SUBJECT: CATAWBA NUCLEAR STATION, UNIT 1, ISSUANCE OF EMERGENCY AMENDMENT REGARDING ONE-TIME EXTENSION OF THE 1B CHARGING PUMP AND THE AUXILIARY BUILDING FILTERED VENTILATION EXHAUST SYSTEM ALLOWED OUTAGE TIME (TAC NO. MD7563)

SAFETY EVALUATION BY THE OFFICE OF NUCLEAR REACTOR REGULATION

AMENDMENT NO. 239 TO RENEWED FACILITY OPERATING LICENSE NPF-35

CATAWBA NUCLEAR STATION, UNIT 1

Catawba 1 1B NV Pump

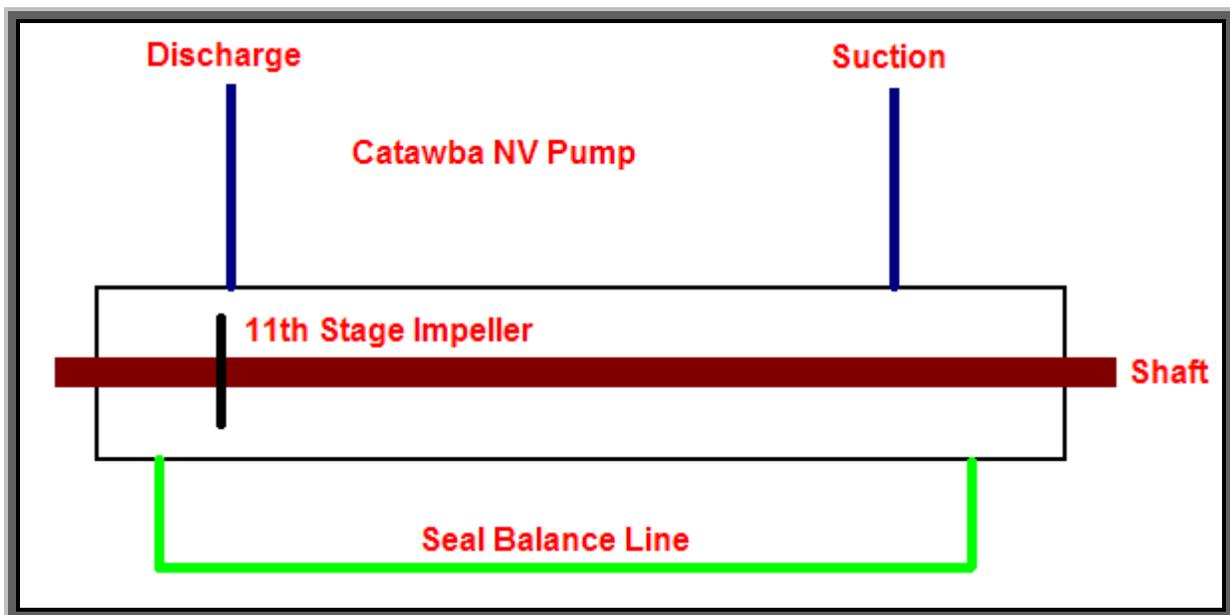
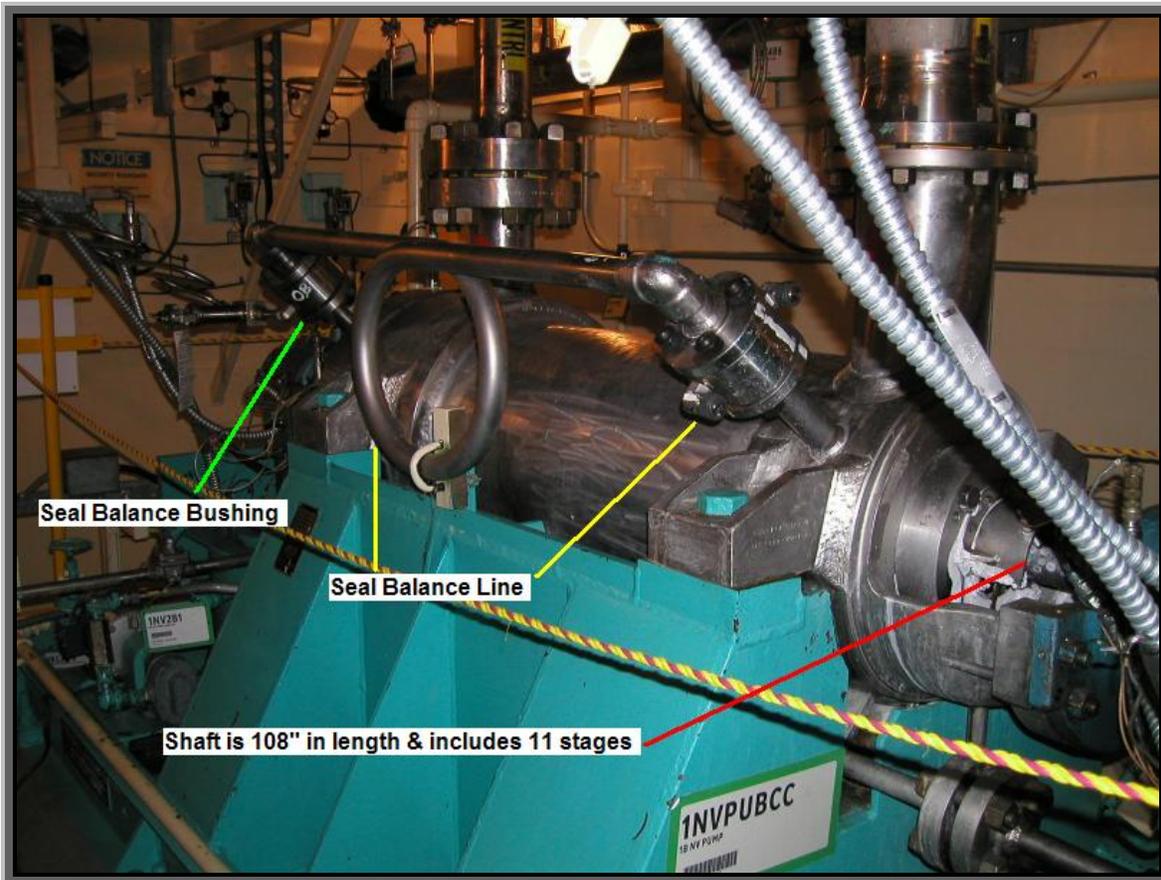
On December 30, 2007, the licensee noted, increased differential pressure (dP) readings on the seal balance line for the 1B NV pump. The seal balance line connects a bushing located after the 11<sup>th</sup> stage impeller (the last one) of the NV pump back to the suction side of the pump and is designed to reduce the loading on the outboard seal package and the thrust bearing. See the diagram below. In the event there is a problem internal to the pump, the flow back through the balance bushing will be adversely affected and the dP (pressure after the 11<sup>th</sup> stage impeller vs. the suction pressure) will show an increase. The licensee reviewed recent data recorded each shift, the dP has increased from a fairly consistent value of ~20 pounds per square differential (psid) to ~35 psid.

The drawing and photo below show the configuration of the 1B NV pump at Catawba 1.

The motor stator temperatures of the 1B NV pump have also shown an increase. Any problems internal to the pump would require more motive force to get the same flow and hence the increased motor stator temperatures reflected in the measured values which tend to confirm the suspected impending failure of the NV pump shaft.

Late on December 30, 2007, local panel indications for high vibration were received and these were then confirmed by licensee maintenance personnel. The largest increase over data taken on December 19, 2007, during a routine surveillance test was on the outboard bearing in the vertical direction which went from a value of ~0.95 mils peak-to-peak to the measured value on December 31, 2007, of ~1.6 mils peak-to-peak.
